SSD 61400212
AB7 (P&E)

STATE SIGNIFICANT DEVELOPMENT APPLICATION 61400212
APPLICANTS: Third.i Crows Nest Residential Developments Pty Ltd

Figure 1. Approved concept design – Dec 2020 (highlights added)

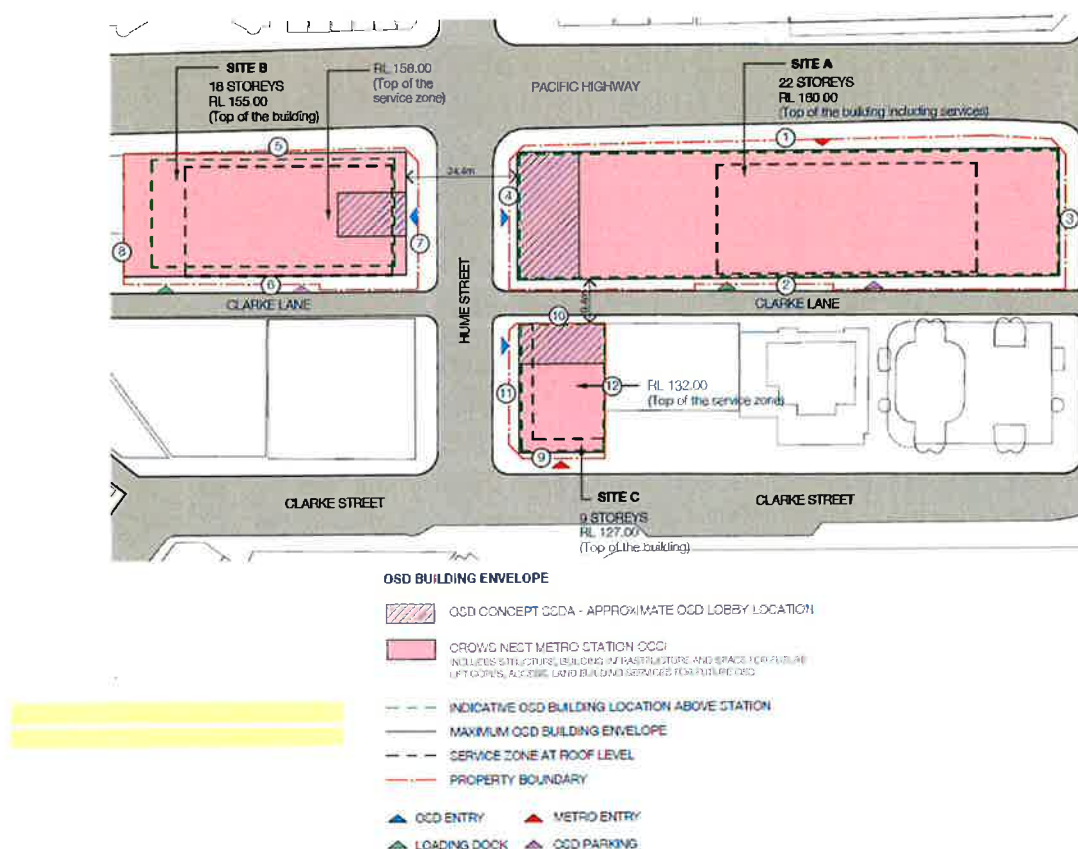
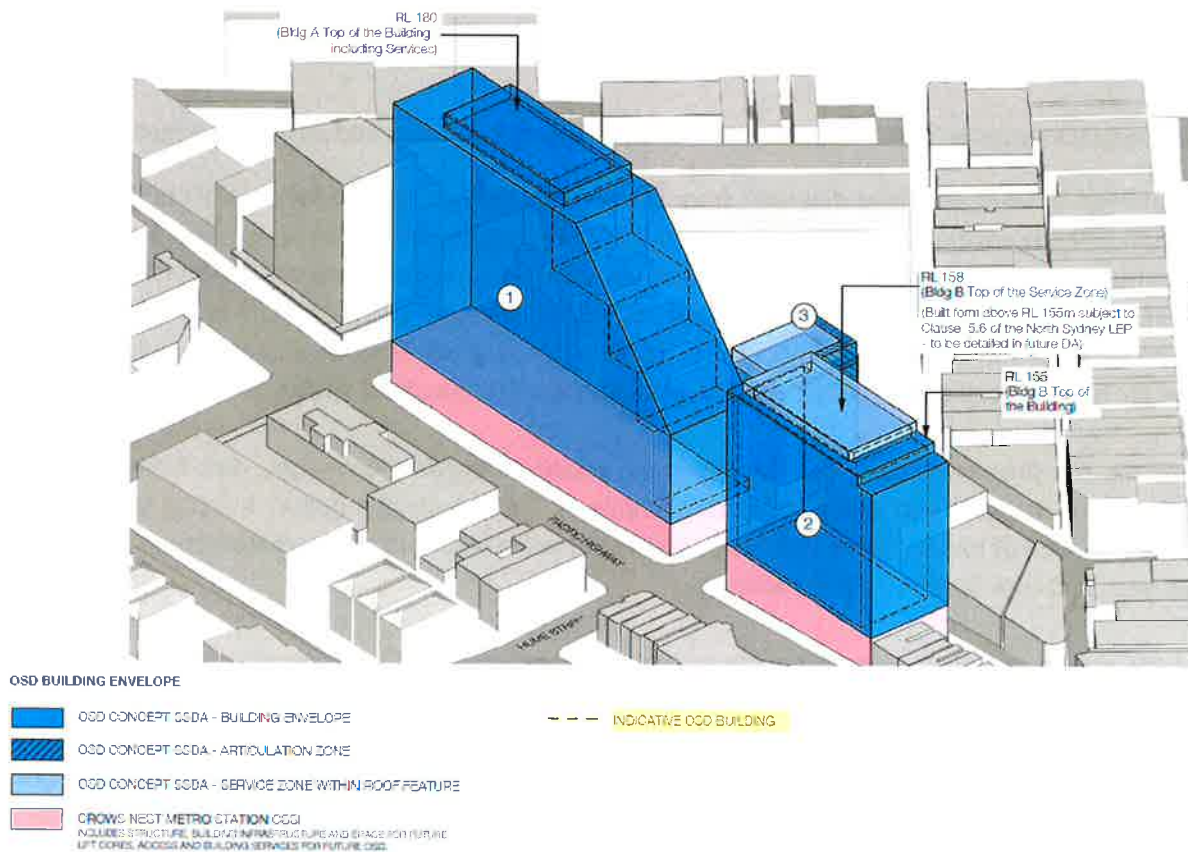
The approved building envelope diagrams from December 2020 include two sets of OSD building outlines: the maximum building envelope and the indicative OSD building location above the station. For Site B, the indicative OSD features a smaller floorplate with above podium setbacks provided along all property boundaries (Figures 2 and 3). The purpose of the two building outline controls is to ensure an appropriate level of articulation to the tower to improve the internal amenity of the residences, retain a better sense of scale at pedestrian level along the Pacific Highway and better reflect the fine grain context of Crows Nest village.

In contrast, the proposed tower fills the maximum approved building envelope, with limited above podium street and lane setbacks and minor articulation (Table 2). This results in a bulkier building that will contribute towards a 'canyon of towers' along the Pacific Highway, having regard to the increased tower heights under the Crows Nest TOD (see Section 2 of this advice).

Figure 3. Comparison of maximum proposed building heights under the 2036 Plan and Crows Nest TOD

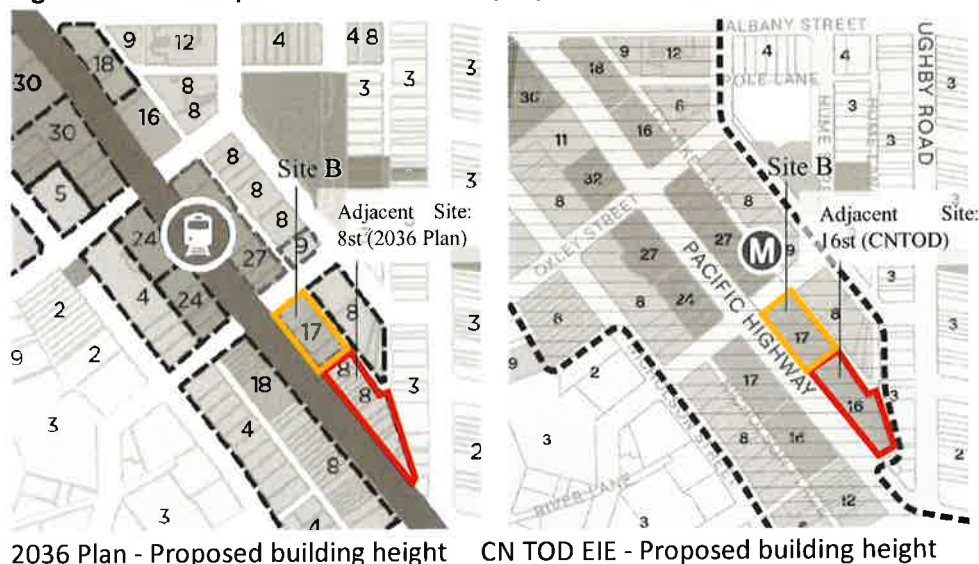
The 2036 Plan (NSW Government 2020) recommended a maximum building height of **8 storeys** for the sites adjacent to Site B to the south (Figure 4). To comply with the Apartment Design Guide (ADG), a total building separation of 21m is recommended between habitable rooms, comprising a 12m setback from Site B and a 9m setback from the adjacent site.

However, the recently published Crows Nest TOD increases the building height for the adjacent site from 8 storeys to **16 storeys** (Figure 4). This change requires a considerably more careful response to the ADG, which

recommends a total building separation of 24m between habitable rooms (12m setbacks from each side of the property boundary) for buildings above 8 storeys. Further, it is worth noting the Urban Design Report (SJB 2024) that underpins the Crows Nest TOD, recommends maximising tower separation with distances of up to 40m (Figure 5).

The proposed Site B building provides a setback of approximately 5–6.285m from habitable rooms to the southern site boundary for level 9-18, falling considerably short of the accepted minimum 12m setback requirement under the ADG and design recommendations of the Crows Nest TOD.

To mitigate these impacts and provide adequate amenity to the residential units, it is recommended that a minimum 12m building setback be provided by Site B along the shared southern boundary.

Figure 5. Limited tower separation distances being sought by the applicant in context with increased building heights proposed under the Crows Nest TOD

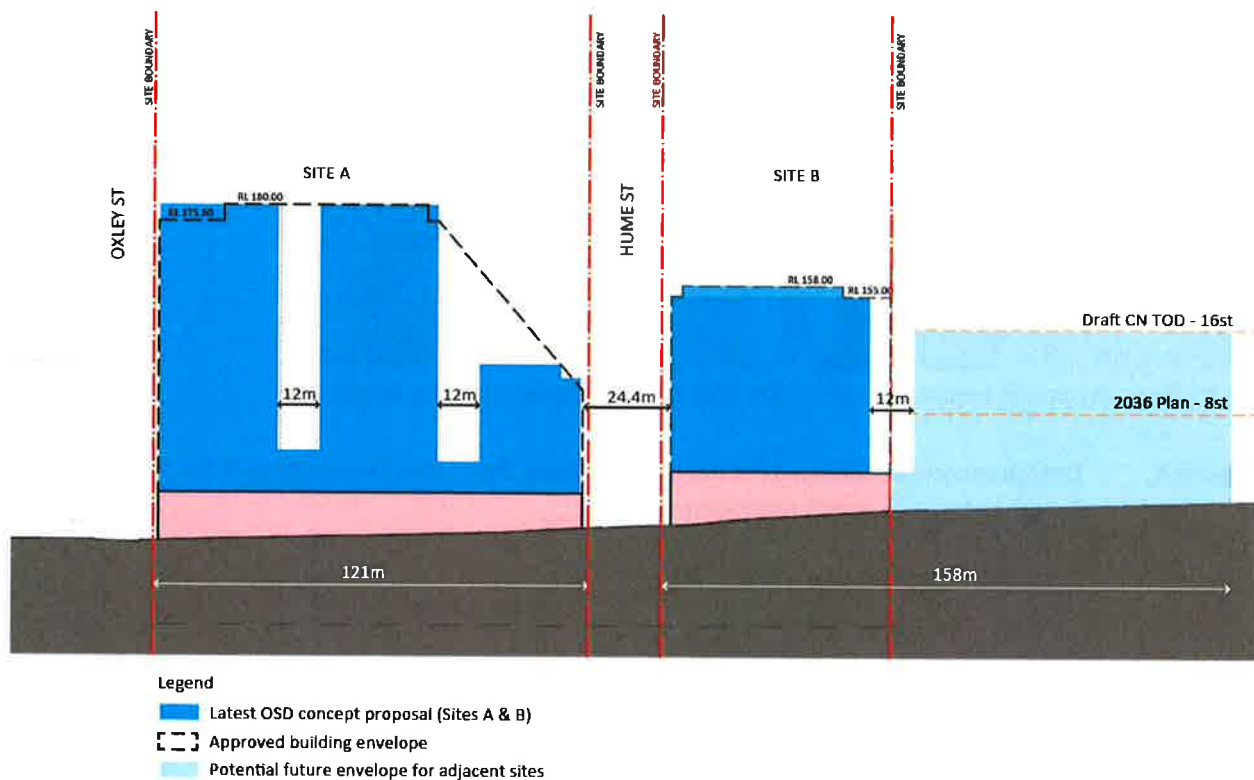
The cumulative effect of poorly separated tall buildings along the eastern side of the Pacific Highway, raises several significant concerns. The anticipated massing will be highly visible from local viewpoints, including Ernest Place, Hume Street Park, Willoughby Road, and the Pacific Highway. Lack of any meaningful gaps or articulation between buildings (Figure 5) will cause a 'wall effect' when looking up or down the highway or from the centre of Crows Nest. It will also cause significant afternoon overshadowing of Ernest Place and Willoughby Road during spring and autumn equinoxes.

In addition, with the Crows Nest TOD also proposing further increases to building heights along the western side of the Pacific Highway, any precedent set by poor separation and articulation of towers on the metro sites, may be repeated, causing a “canyon effect” down the highway. The Site A block spans approximately 121m, while the combined length of the Site B block, including the adjacent sites with uplift, extends to 158m. If the proposed narrow building separations are maintained for these two high-density, high-rise blocks along Pacific Highway, it will result in an exceptionally long and largely continuous built form with only a visual break at Hume Street. This must not set a precedent for the western side of the Pacific Highway.

Figure 6. Proposed open air above ground car parking level of Site B with nil setback to the south

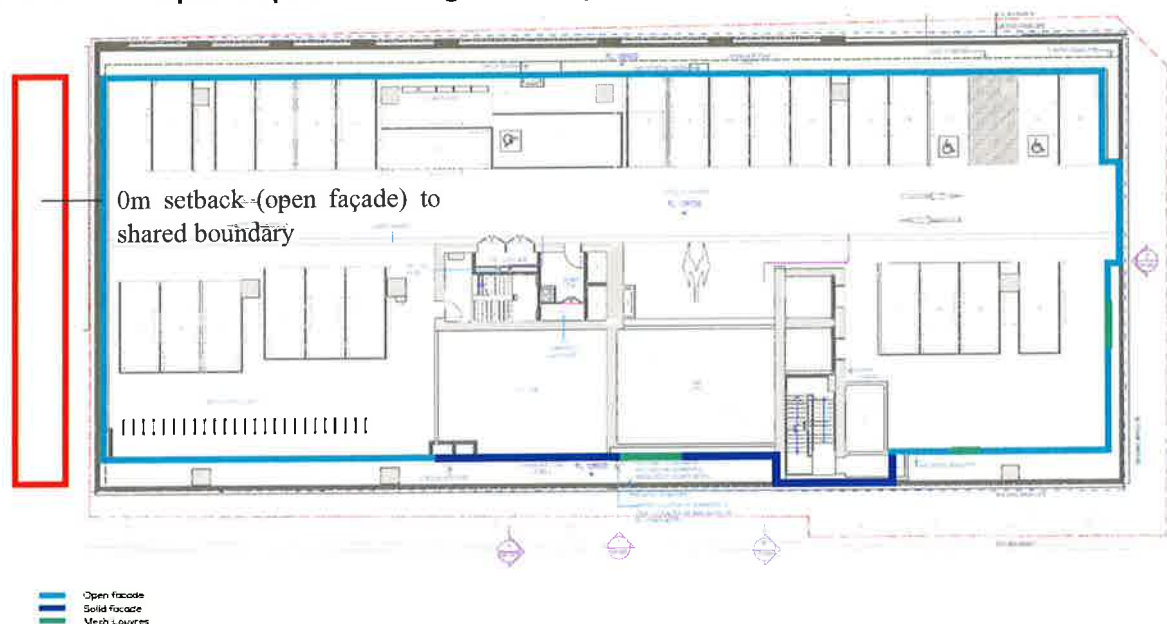
The proposed building includes two levels of car parking on Levels 5 and 6, with a direct open interface to the adjacent site to the south and a 0m setback to the shared boundary (Figure 7). The façade at this interface is designed as an open structure, featuring perforated metal panels.

The Crows Nest TOD planning recommendations indicate that the adjacent site is intended for redevelopment with a 3-storey street wall accommodating non-residential uses, with residential uses above. As such, the proposed open façade car parking levels with a nil setback at Site B will directly face future residential units on the adjacent site.

This design raises significant concerns, as it would have a detrimental impact on the residential amenity of the adjacent site, particularly in terms of privacy, noise, air quality and visual intrusion.
